Proposal: Concurrent rezoning and State Significant development application for the construction of one build-to-rent apartment building and two build-to-sell apartment buildings over a podium, the development includes infill affordable housing.

Property: 1-7 Burton Street, 3B-11 Loftus Street and 10-12 Gipps Street, Concord

Ref No: SSD-84962709

The City of Canada Bay has reviewed the EIS and supporting documentation and objects to the application in its current form due to several concerns, which are outlined below.

Figure 1: Overshadowing from the PRCUTS planning proposal built form (12-storeys & 2.3:1) at 2pm mid-winter.

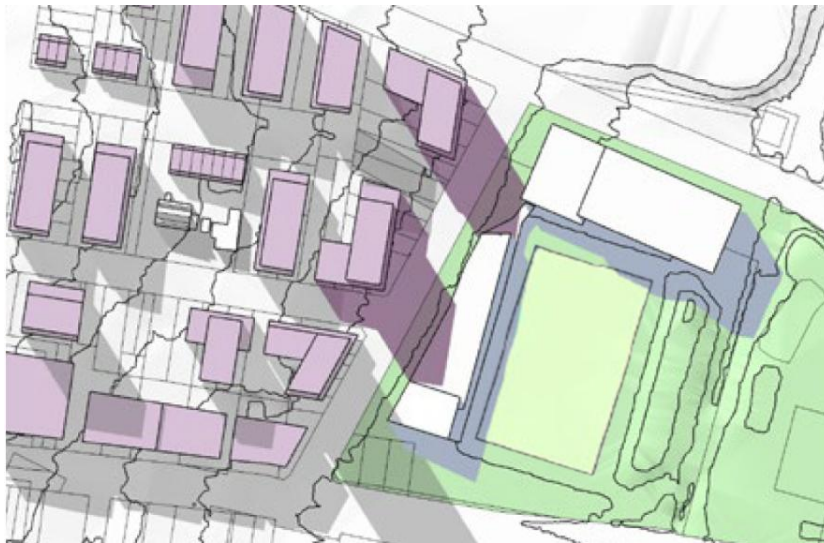
Council's position is informed by a consistent and evidence-based assessment process. As part of its precinct-wide planning work for Stage 2 of the *Parramatta Road Corridor Urban Transformation Strategy* (PRCUTS), Council prepared a planning proposal identifying a compliant built form of approximately 12 storeys and 2.3:1 FSR, which demonstrated minimal overshadowing impacts (See figure 1).

Figure 2: Overshadowing from the proponent's SSD proposed built form (29 storeys & 6.4:1) at 2pm mid-winter (red outline is additional)

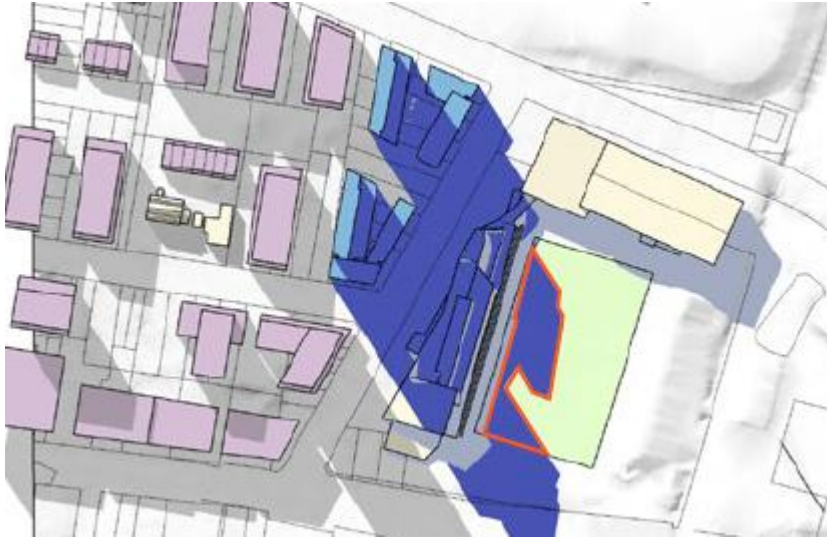
The proponent's scheme, ranging from 23 to 29 storeys with a significantly higher FSR, substantially exceeds this envelope and results in additional mid-winter overshadowing of the playing surface (See figure 2). Independent agronomic review confirms that this increase in shadow would adversely affect turf health, resilience and the safe use of the facility, particularly during periods of peak winter use.

- the proposal be updated and amended to demonstrate that there will be no additional overshadowing of Concord Oval between, at least, 11am and 2pm in mid-winter.

Figure 3: Overshadowing from Studio GL's alternative built form (18 storeys & 3.4) at 2pm mid-winter

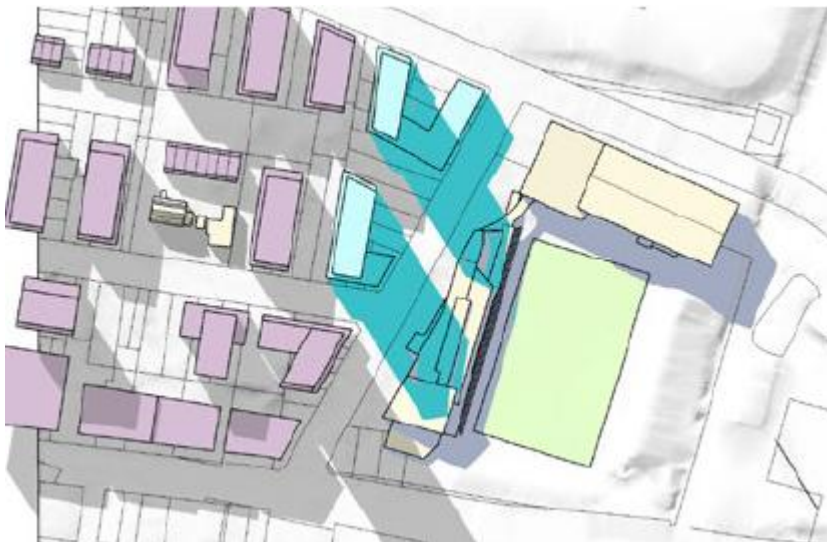
In response to a subsequent site-specific proponent-led proposal seeking increased height and density, Council engaged Studio GL in February 2025 to test the environmental limits of the site. This analysis found that a building of approximately 15 storeys and 3.0:1 FSR could be achieved while maintaining acceptable solar access outcomes. This envelope was endorsed by Council as part of its broader PRCUTS Stage 2 planning proposal.

Following declaration of the site as State Significant Development (SSD) with a concurrent rezoning by the Housing Delivery Authority, enabling a substantially larger built form of up to 29 storeys and 6.4:1 FSR, Council undertook further testing to assess whether any additional uplift could be supported. This subsequent analysis confirmed that an upper limit of 18 storeys and 3.4:1 FSR represents the maximum development capacity of the site having regard to overshadowing constraints (See figure 3).

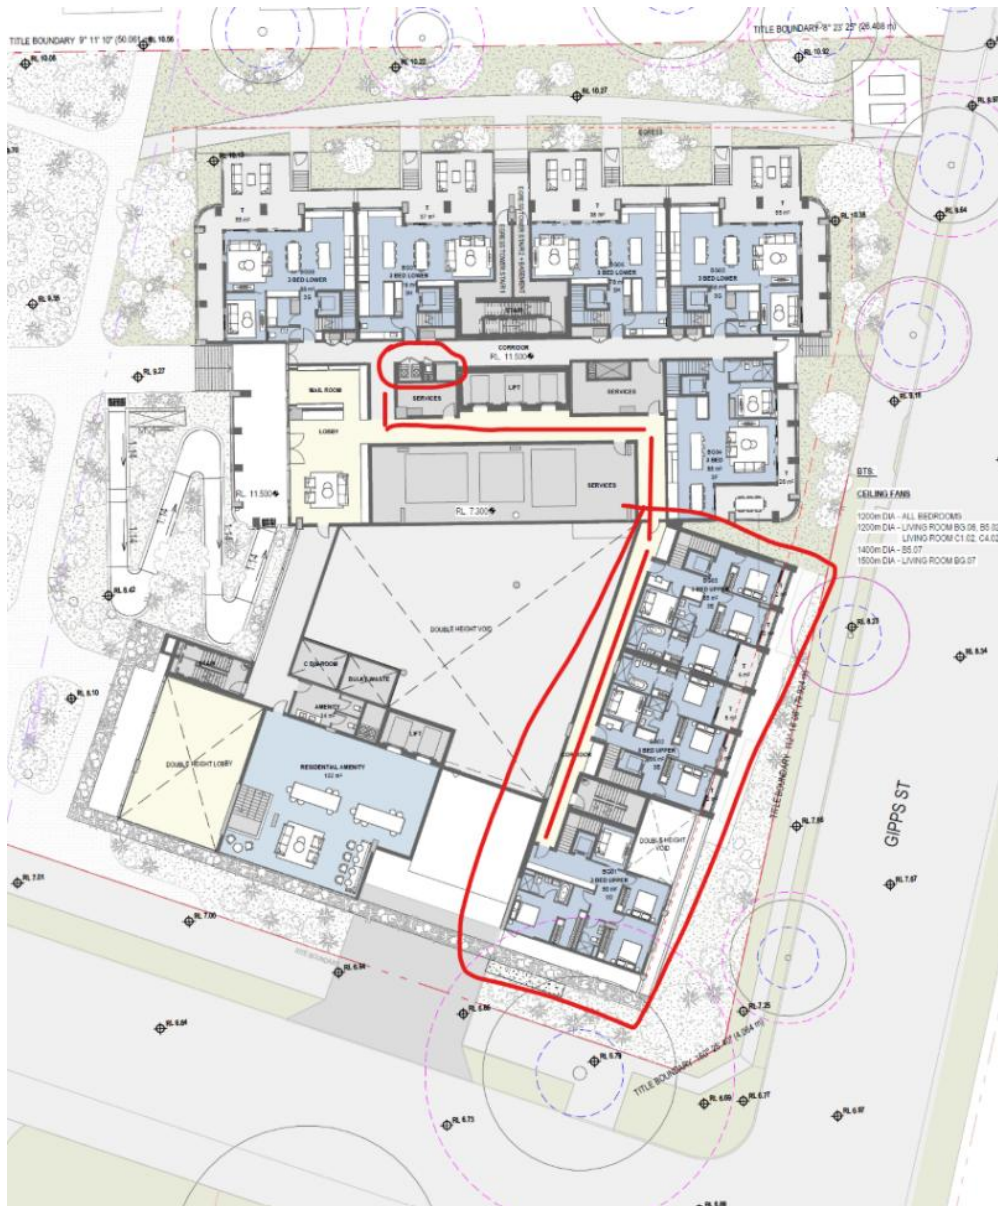
- The OWMP indicates that the development will be serviced by Council once per week using a Heavy Rigid Vehicle (HRV).
- Waste collection is proposed to occur onsite; however, the suitability of vehicle access and manoeuvrability has not been confirmed.

- The Traffic Engineer review the swept path analysis for the HRV to confirm safe and adequate onsite collection.
- Confirmation be provided that the proposed servicing arrangement is acceptable.
